**AEC DISTRIBUTION FOR PART 50 DOCKET MATERIAL**  
 (TEMPORARY FORM)

PLANT NAME: Oconee #1

Re: Oc onee Unit 1  
Docket No. 50-269

On September 20, 1974, Duke Power Company submitted proposed changes to the Oc onee Nuclear Station Technical Specifications and the Babcock & Wilcox Report BAW-1409, "Oc onee 1, Cycle 2 Reload Report," to support operation of Oc onee 1, Cycle 2 at rated power.

Figure 3.5.2-1A1

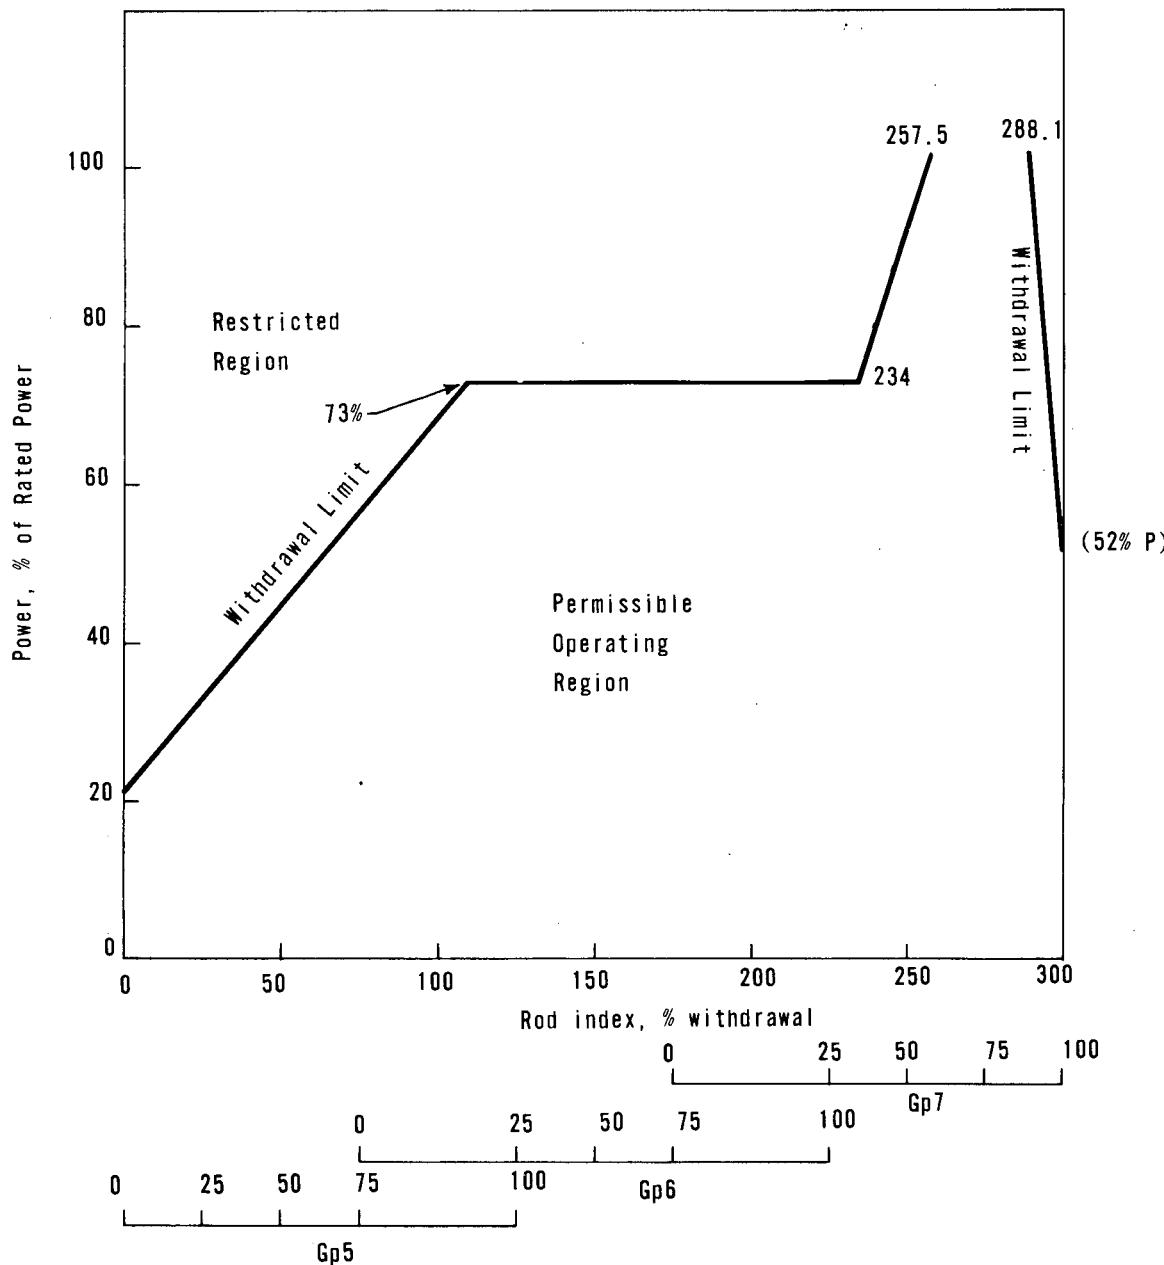
1. Figure 3.5.2-1A1 of proposed Technical Specification 3.5.2 satisfies both the Interim Acceptance Criteria and Appendix K to 10CFR50. This figure shows the control rod group withdrawal limits for four pump operation for the first 250 full power days of operation. Figure 3.5.2-1A2, which shows the withdrawal limits in effect after 250 full power days of operation, satisfies only Appendix K to 10CFR50. In the unlikely event that the B&W ECCS evaluation model is not approved prior to completion of 250 effective full power days of Cycle 2 operation (approximately August, 1975), Technical Specification 3.5.2 will be appropriately modified to meet both the Interim Acceptance Criteria and Appendix K.

1. Rod index is the percentage sum of the withdrawal of the operating groups.
2. The withdrawal limits are modified after  $250 \pm 5$  full power days of operation.
